ADDENDUM NO. 01

1 April 2010

Project: **A NEW TRANSPORTATION FACILITY**
Dickinson Independent School District

Bay Project No.: **0806**

ADD-01-01
 0806
 1"=50'-0"
 04/01/10
 C1.00

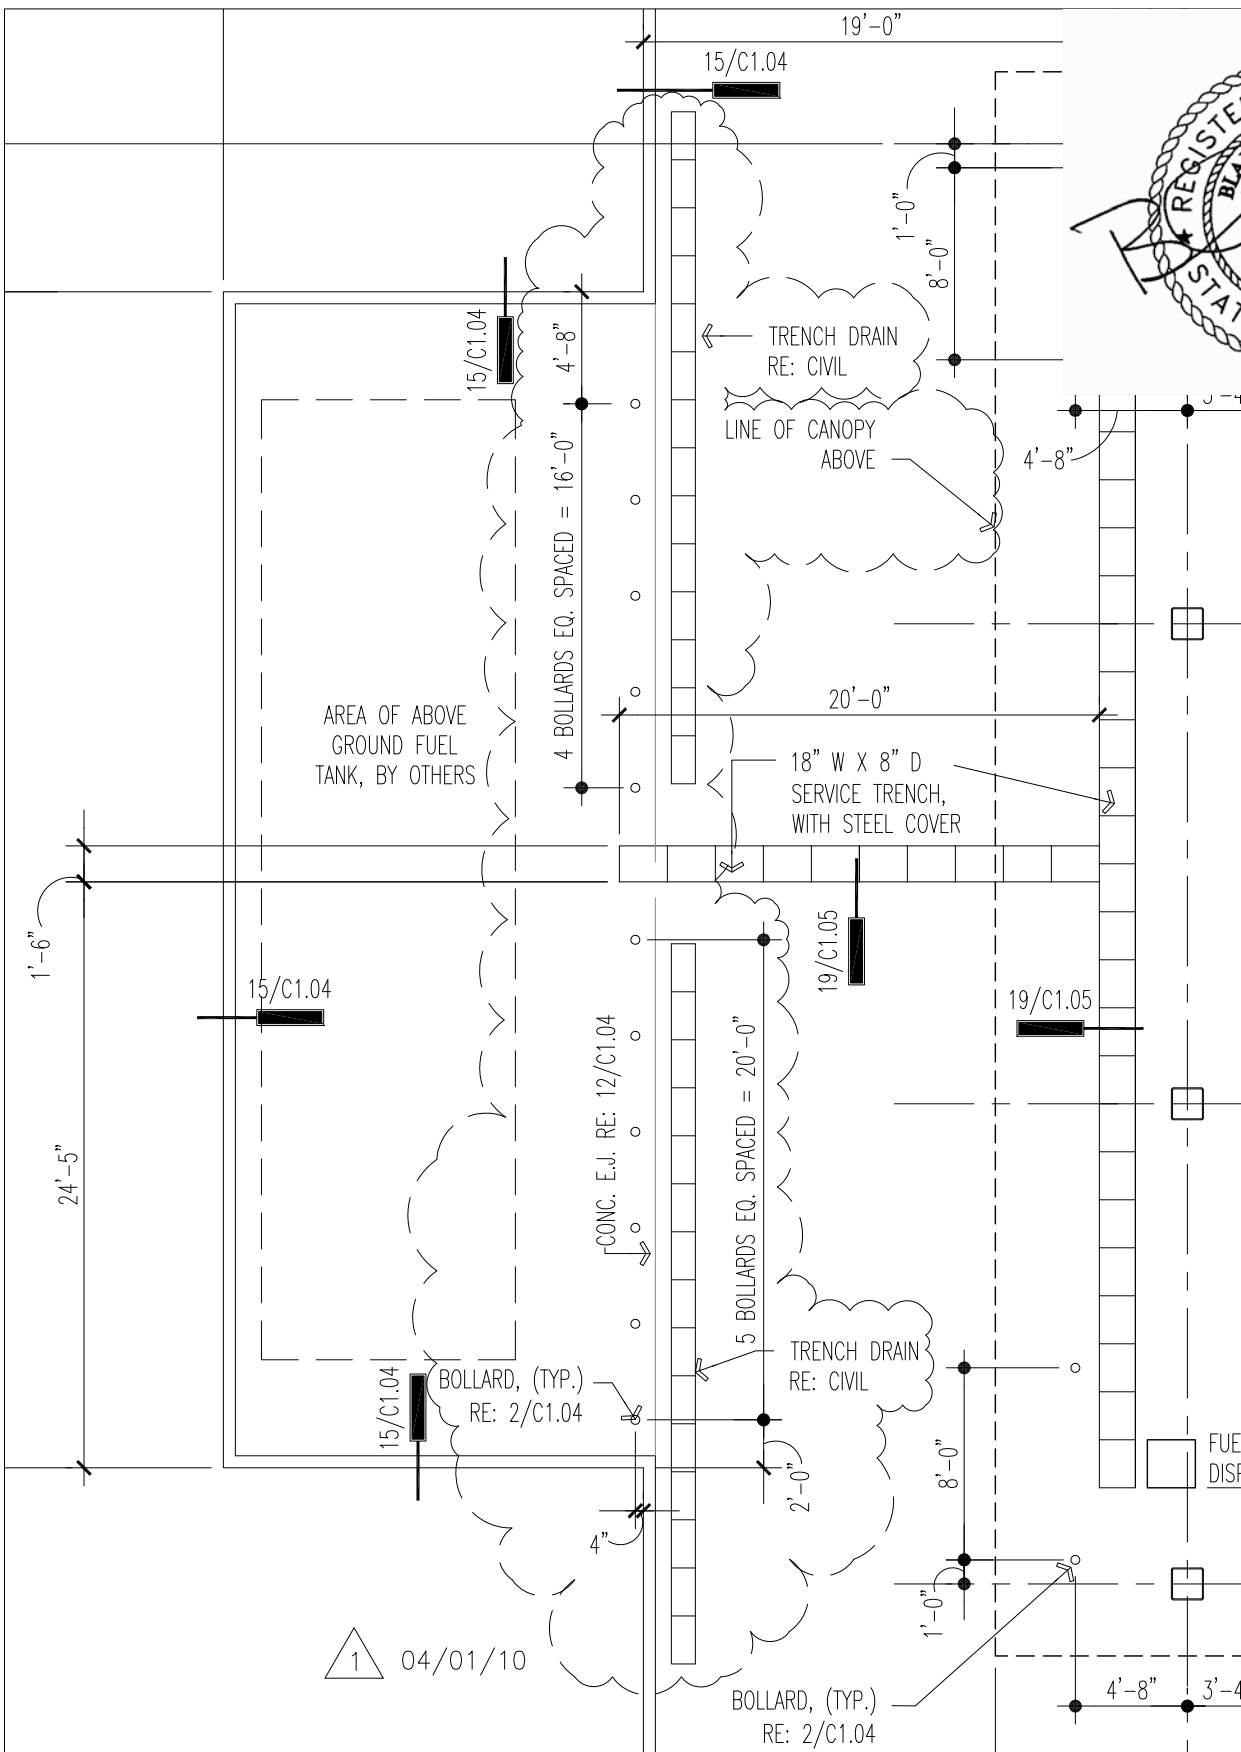
13. Cover Sheet: Add sheet C1.05 Enlarged Site Plan and Details to sheet listing.
14. Sheet C1.00 Site Demolition Plan: At existing gymnasium building; remove flatwork as shown on attached sketch **ADD-01-01**.

15. Sheet C1.00 Site Demolition Plan: Delete keyed notes 2 and 3 at existing building as shown on attached sketch **ADD-01-01**.
16. Sheet C1.00 Site Demolition Plan: 18/C1.00 keyed notes, revise note 10 to read: "DEMOLISH EXISTING CONCRETE STRUCTURAL BLEACHERS COMPLETE".

17. Sheet C1.03 Enlarged Site Plan North: Delete note "EXISTING SIDEWALK" at North face of existing gym and replace with "NEW SIDEWALK" to correspond with flatwork deleted per attached sketch **ADD-01-01**.

ADD-01-02
0806
1/8"=1'-0"
04/01/10
C1.05

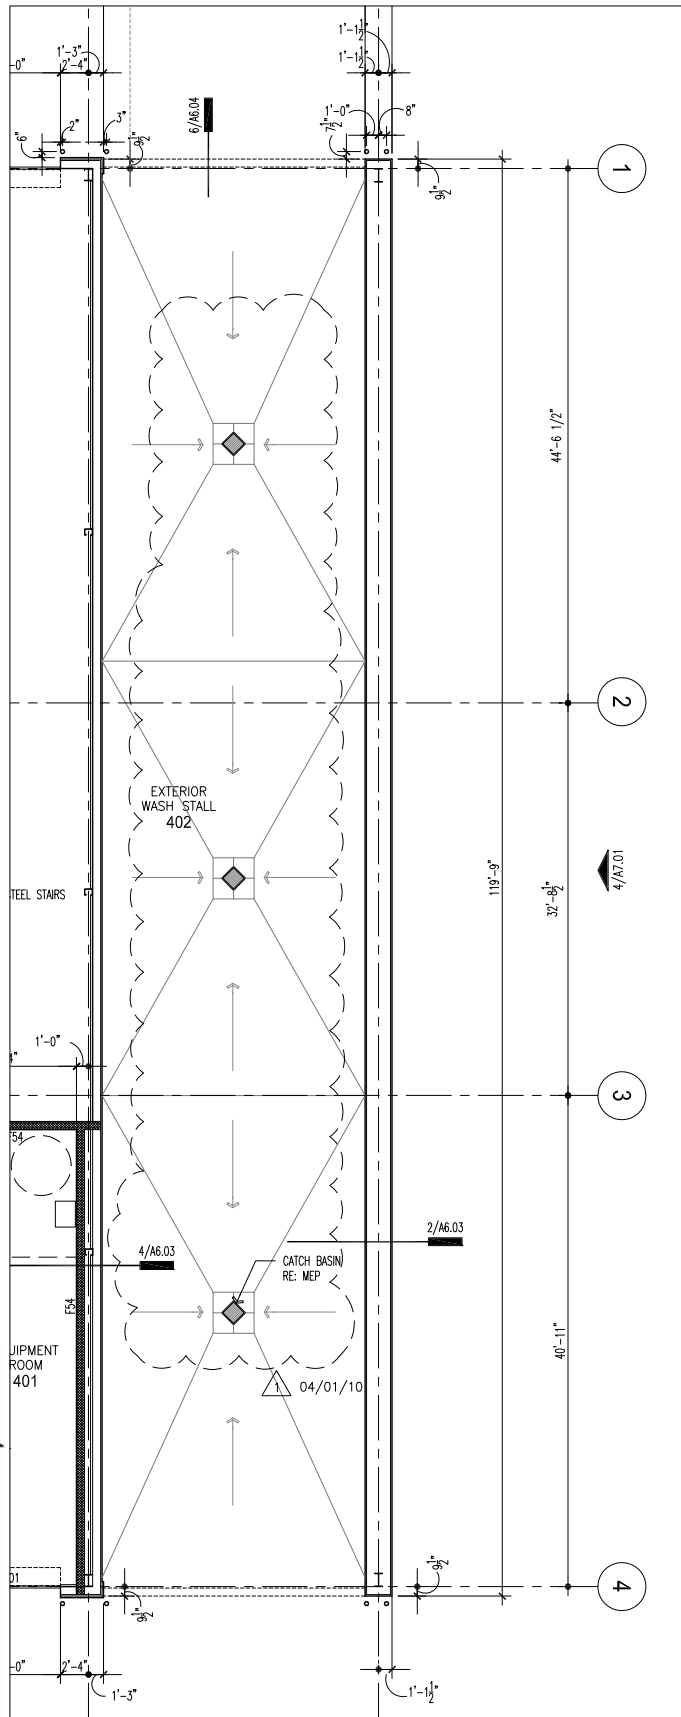
18. Sheet C1.05 Enlarge Site Plan and Details: Revise plan per attached sketch **ADD-01-02** to include bollards and Trench Drains in Fuel Service Area.

ADD-01-03
 0806
 1/16"=1'-0"
 04/01/10
 A2.01

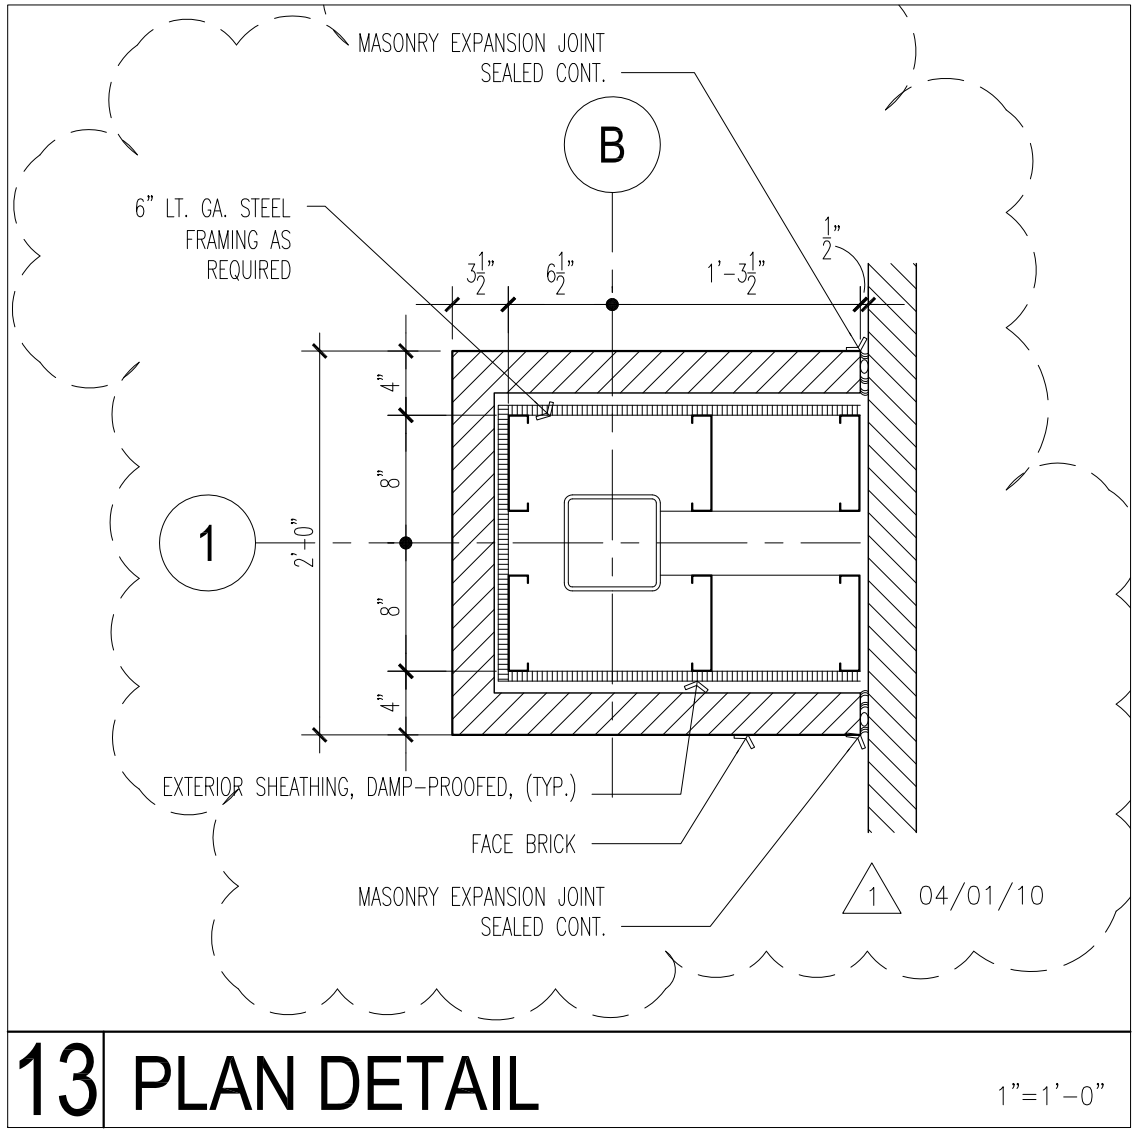
19. Sheet A2.01 Floor Plan Transportation Building: Revise plan per attached sketch **ADD-01-03** to include catch basins in Exterior Wash Stall 402.
20. Sheet A3.01 Plan Details: Revise plan detail 13/A3.01 per attached sketch **ADD-01-04**.
